Product/Process Change Notice (PCN)

PCN #: PCN_IndPD2HV_20180201

Product Affected: WE-PD2HV Size 1054

Samples:

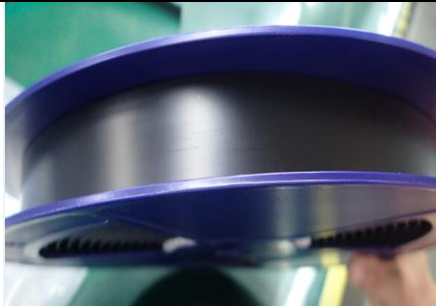
In order to improve the transportation and handling safety, Würth Elektronik will change the packaging by implementing a new Reel and carton protection system.

Due to this change the standard packaging quantity will change as detailed in below shown table.

Protective layer: Foam plastic	Protective layer: 0.5mm Plastic cover

Carton corner protection: Bubble foil	Carton corner protection: Carton triangle
Quantity/Reel: 500 pcs Quantity/Carton: 2000 pcs	Quantity/Reel: 500 pcs Quantity/Carton: 3000 pcs
RELIABILITY / QUALIFICATION SUMMARY: Packing is now according: WES_Packaging_Specification_rev.2.1	
DATA SHEET CHANGE: ☐ Yes ☒ No
